# UNITED STATES PATENT AND TRADEMARK OFFICE

10/622,970

## Office Action Summary

## **DETAILED ACTION**

FIG. 2

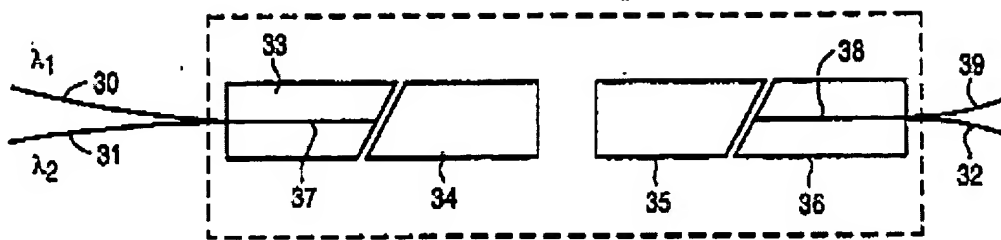
Regarding claim 10, as seen in his Figure 2 (reproduced below), Pan discloses an optical coupler comprised of at least a plurality of optical fibers (30, 31), the first device (34) disposed in optical communication with a second end of each of the optical fibers (30, 31), one second device (Fig. 20, 214) disposed in optical communication with the first end of one of the optical fibers, another second device (214) disposed in optical communication with the first end of another optical fiber, with the at least plurality of optical fibers (30, 31) having each one of its second ends placed head to head with the first device (34).

Regarding claim 11, a ferrule (33) of Pan also retains the second ends of optical fibers (30, 31).
